48 Clinton Street

Site Plan Application

Hudson Planning Commission	SITE PLAN REVIEW
Case No. 2021-618	June 14, 2021

re: **Proposed Smiths Curated Building**
48 Clinton Street, Hudson, OH 44236

1
CONSTRUCTION
SITE PLAN
SCALE: 1/8" = 1'-0"

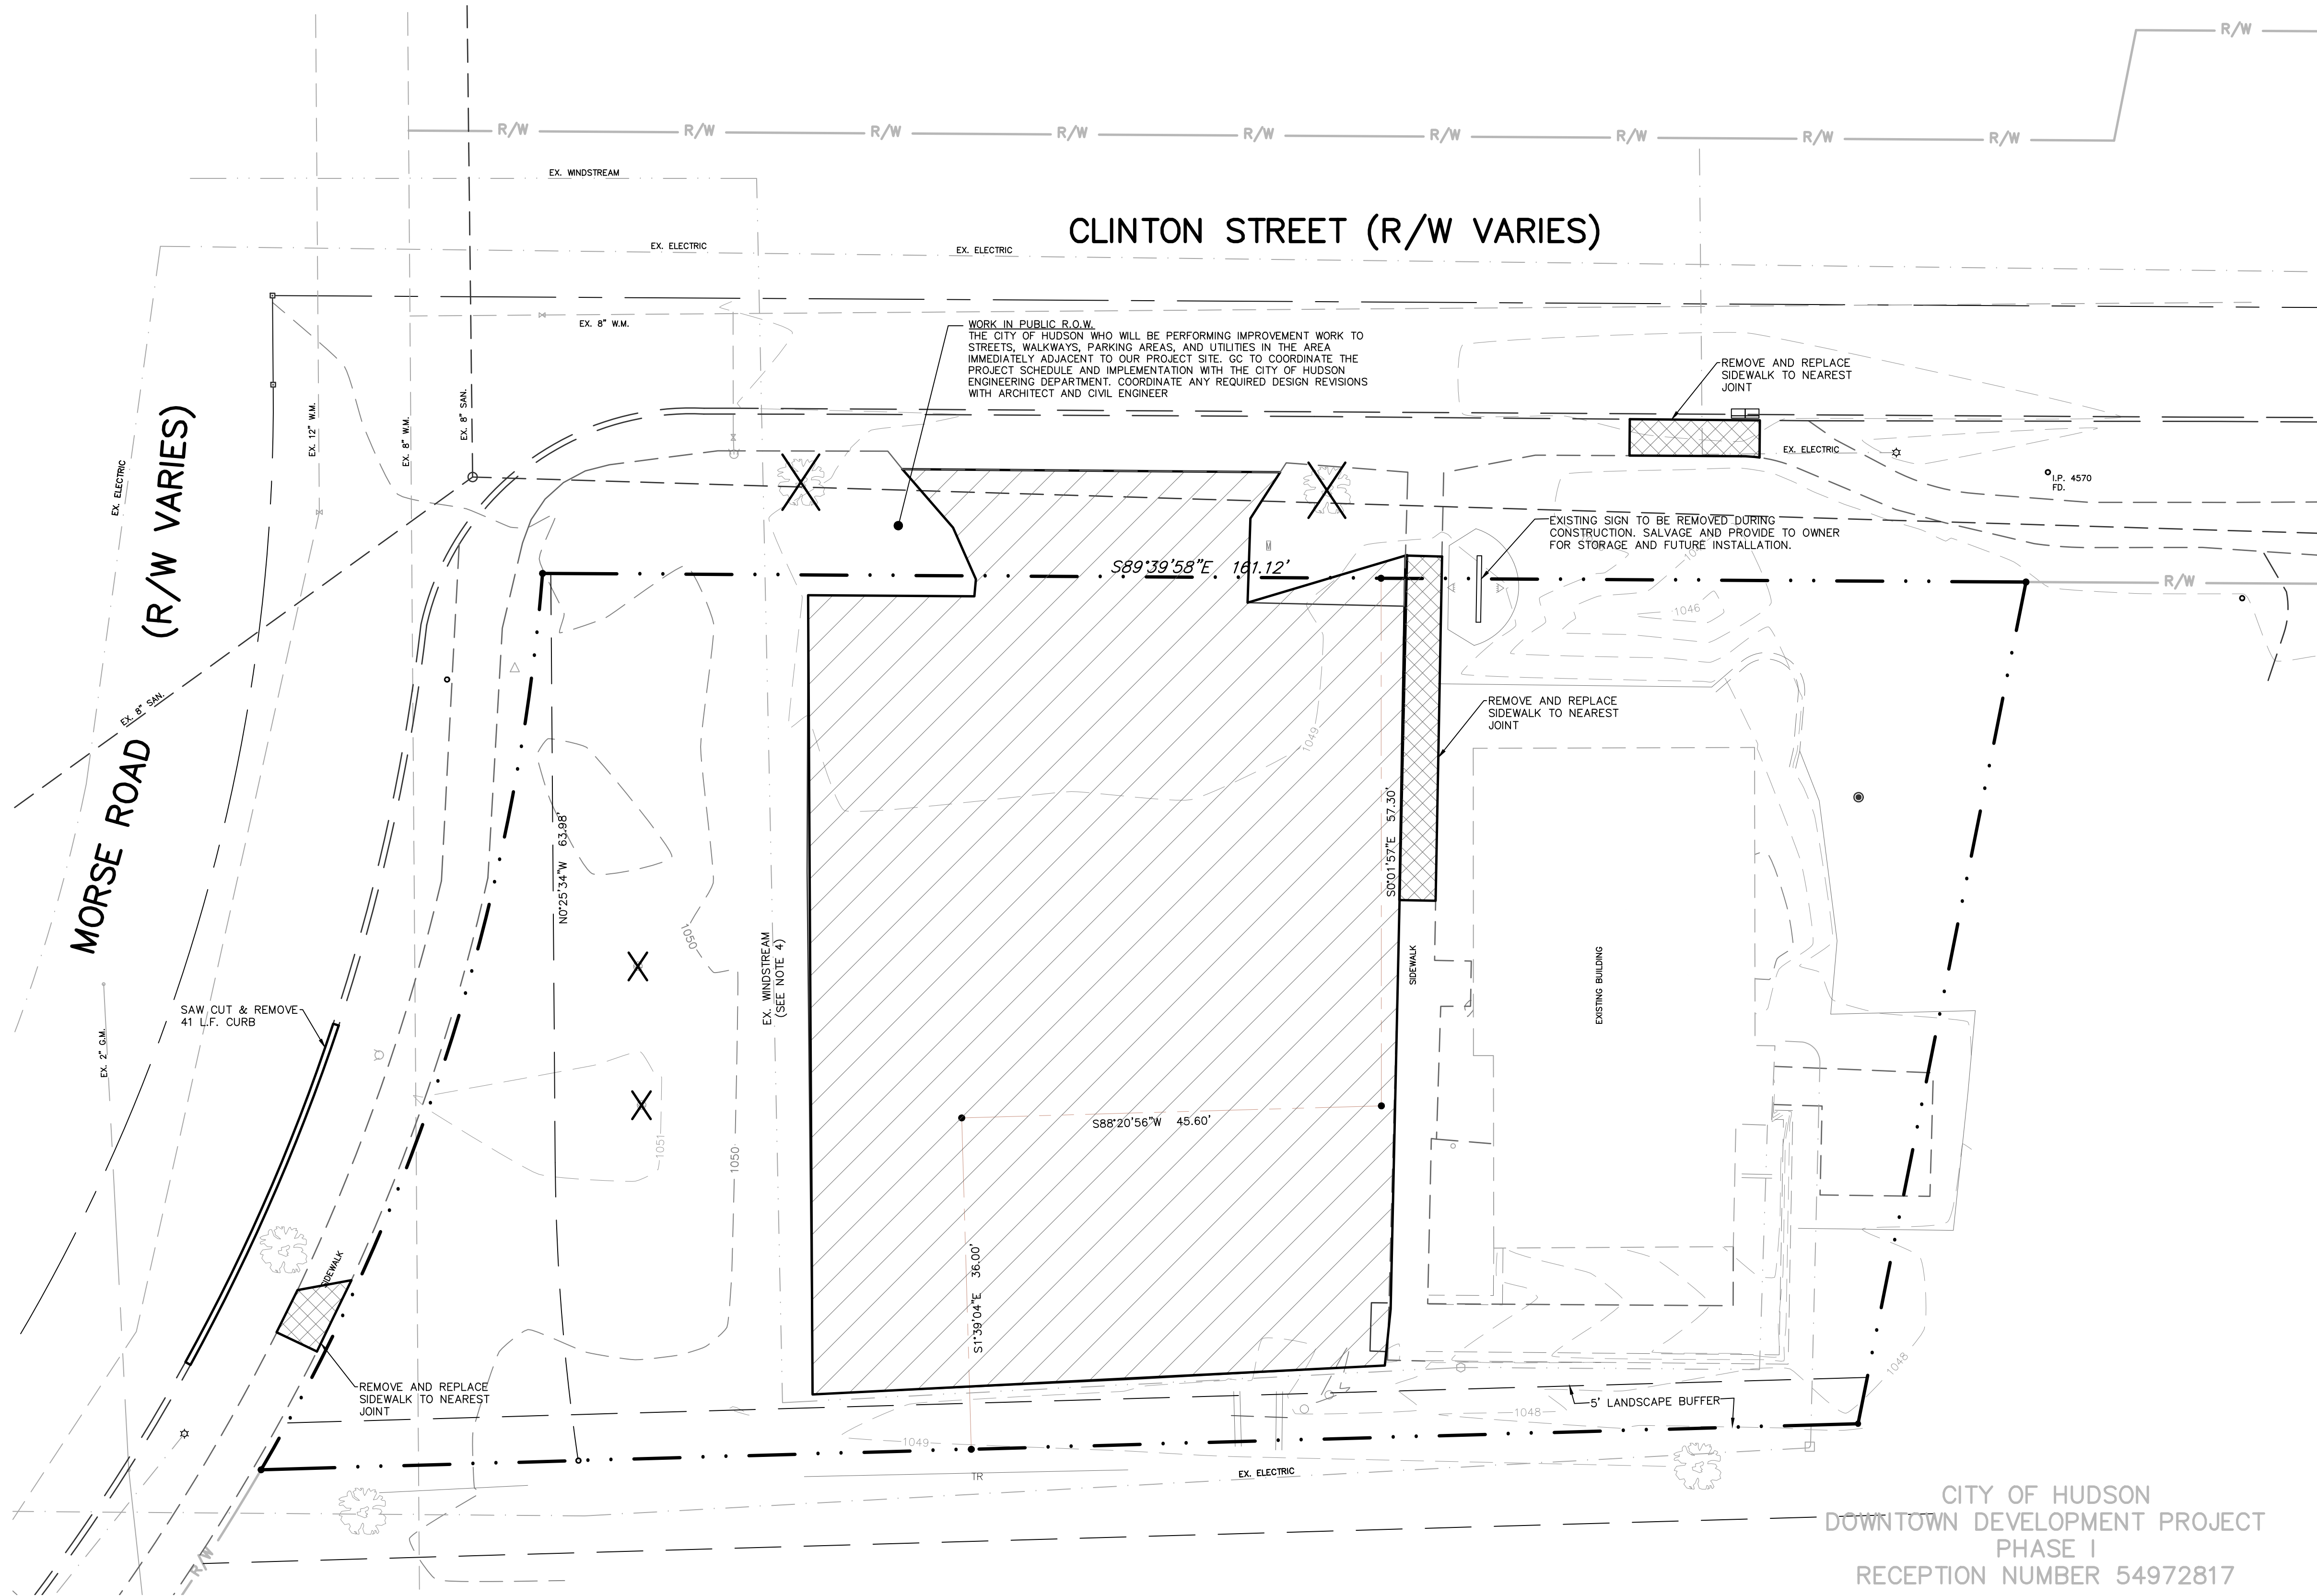
- Driveway access at Morse Road has been shifted south 10-15 ft and parking area has been realigned. Realignment of driveway would avoid replacement of fire hydrant and will allow additional parking setback from the property line.
- Building has been redesigned; however, the footprint remains unchanged. AHBR approved the design on June 9, 2021

- ☒ **Parking** The applicant has proposed 14 spaces onsite with 22 existing on street spaces within in 300 feet of the parcel and 5 proposed on-street spaces for a total of 41 spaces. Staff notes the drive/parking realignment depicted in the current plans would only allow for stalls with a 17' depth along the southern portion of the parking area where code requires a 19' stall length. However, Section 1207.12 permits the required stall length to be reduced by 2 ½ feet to compensate for a vehicle overhang. Application complies with applicable standards.

GRADING
PLAN

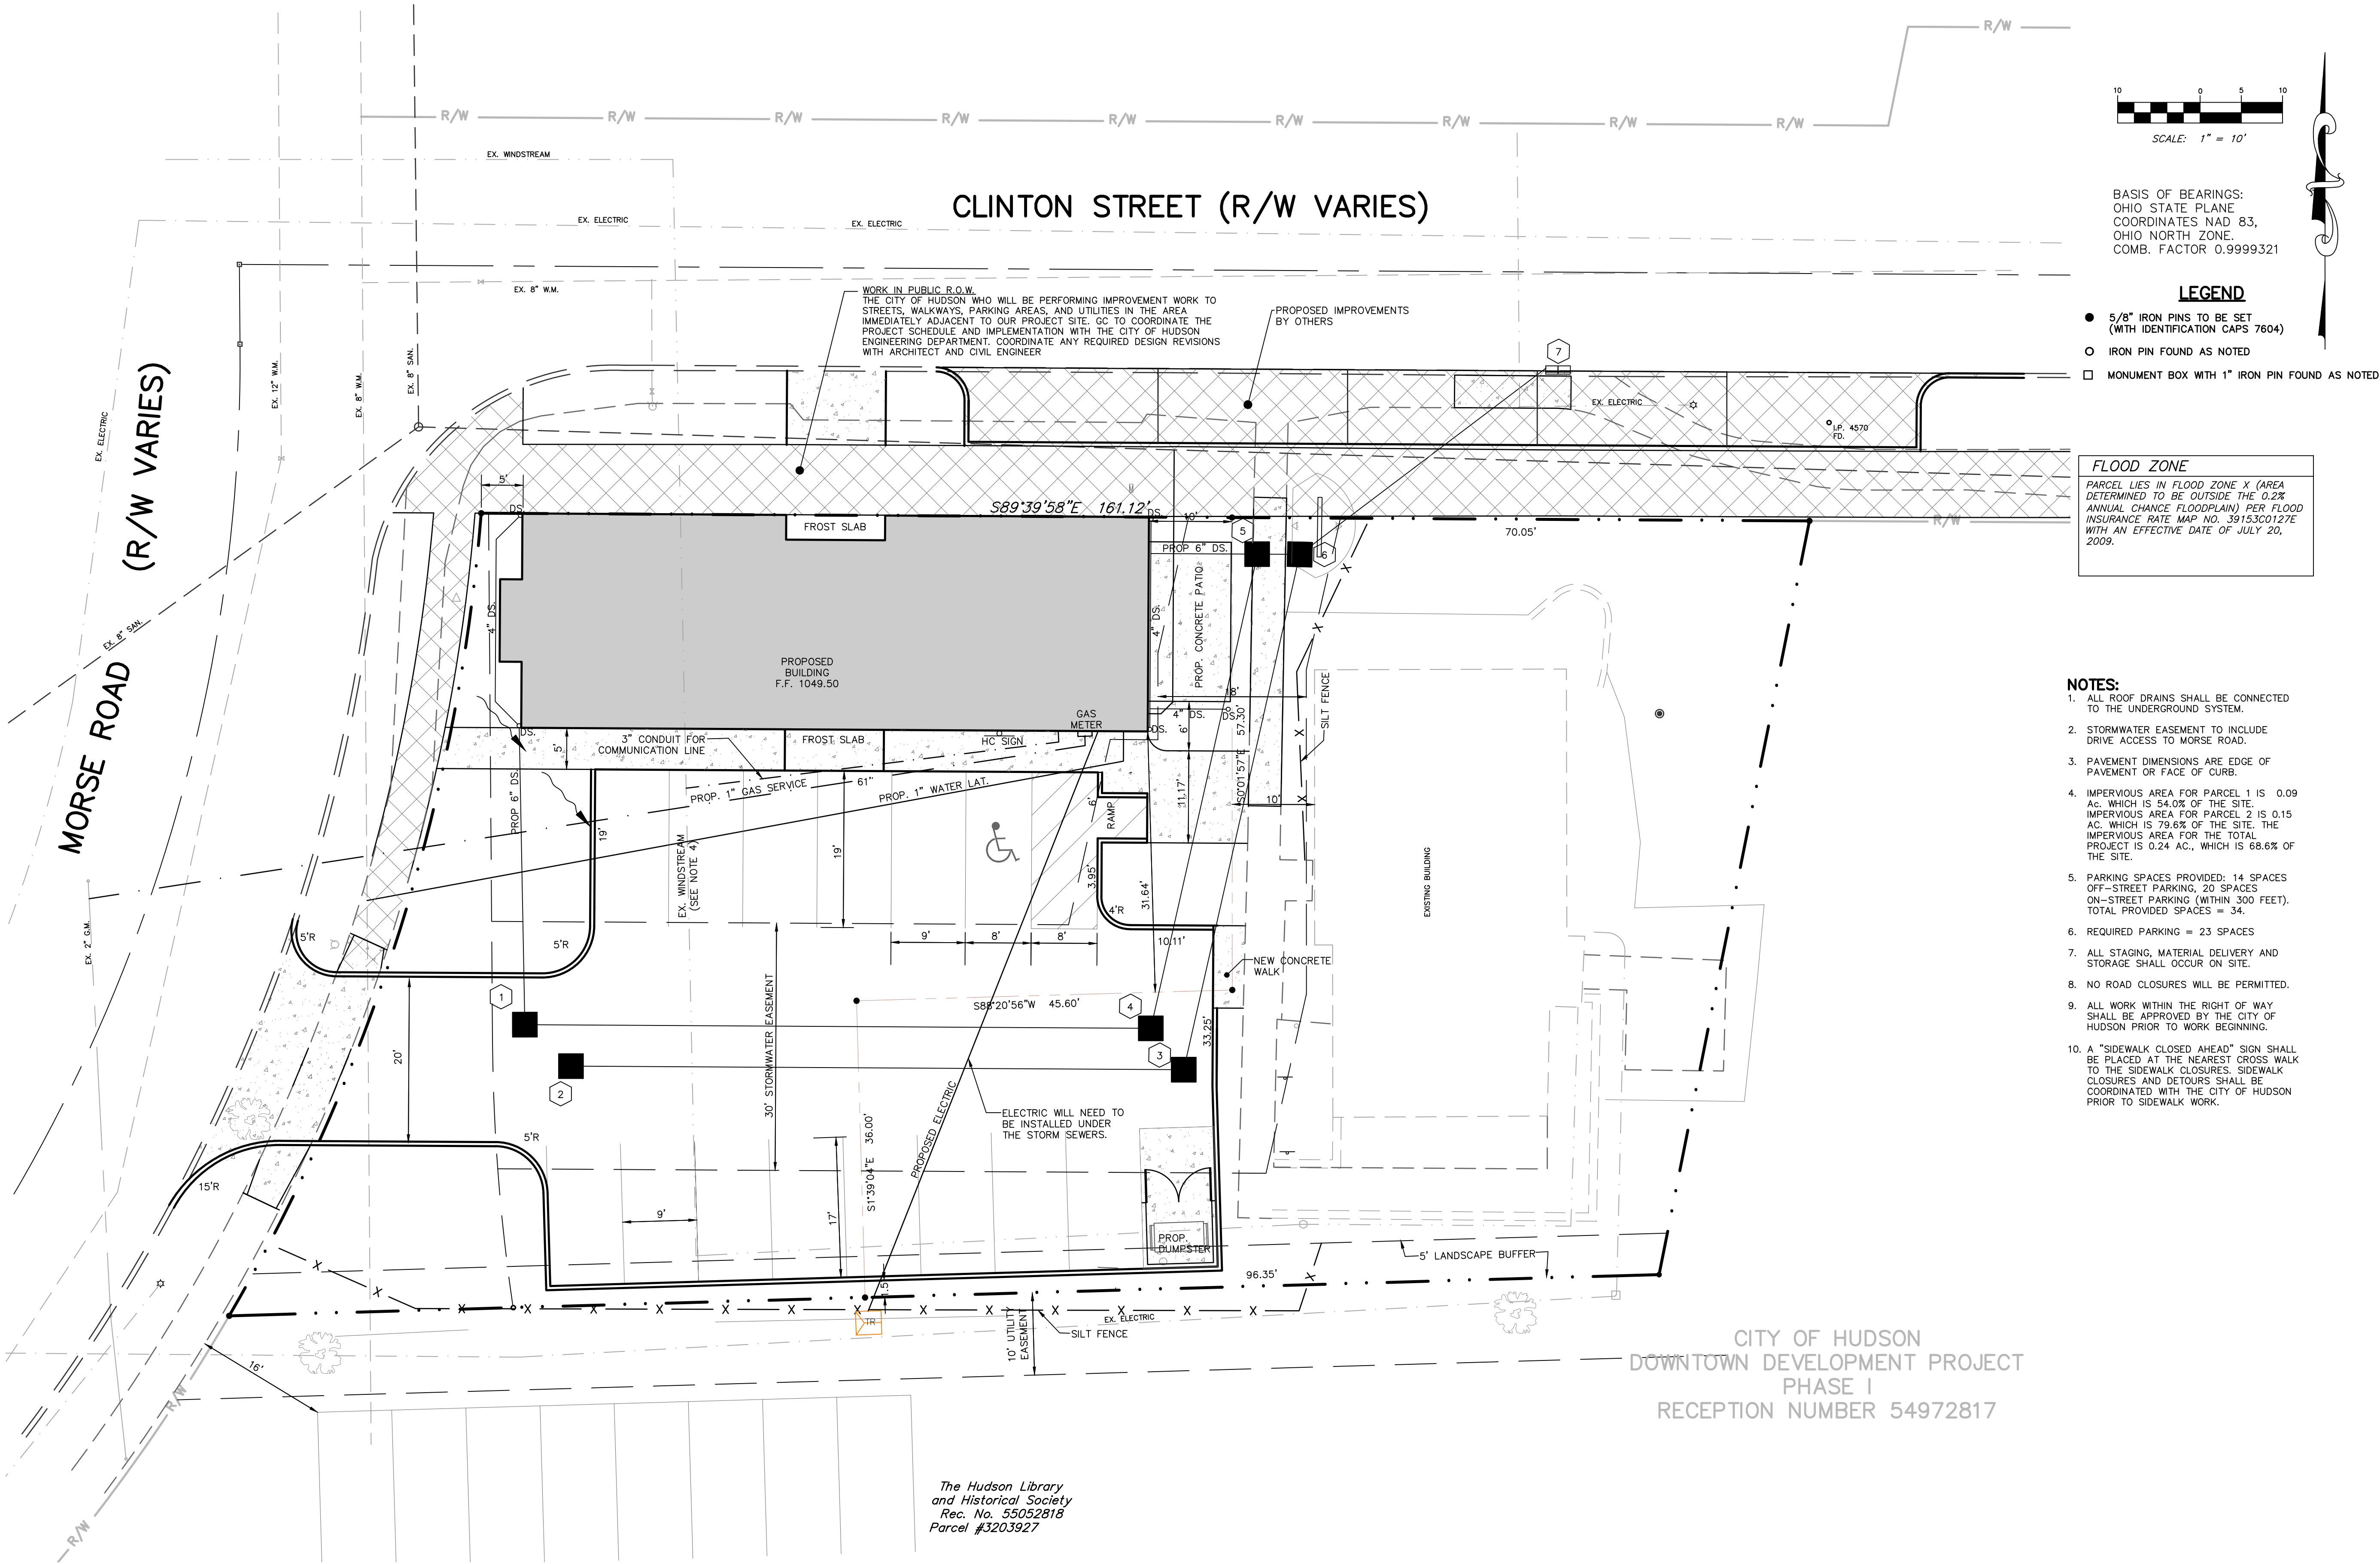
5. Label all silt fence on the plans and provide a silt fence detail. Silt fence shall be installed downstream of all disturbed areas. Also show inlet protection on nearby inlets that could receive sediment laden runoff from construction and provide an inlet protection detail.
6. Provide a catch basin detail for CB's 1-5 or indicate the standard ODOT detail to be used.

7. A professional engineer shall stamp and sign the storm water management plans and calculations.
8. Include the 2- and 5-year storm event peak flow rates in the summary chart in the report.
9. Submit a draft copy of the Long-Term Maintenance Agreement for the underground detention pipes. The City LTMA Template has been uploaded for your use.
10. A 30' wide access easement to the City of Hudson shall granted to the underground detention pipes and shall also be 30' past the 100-year water surface of the system. **Show the limits of this easement on the improvement plans.**
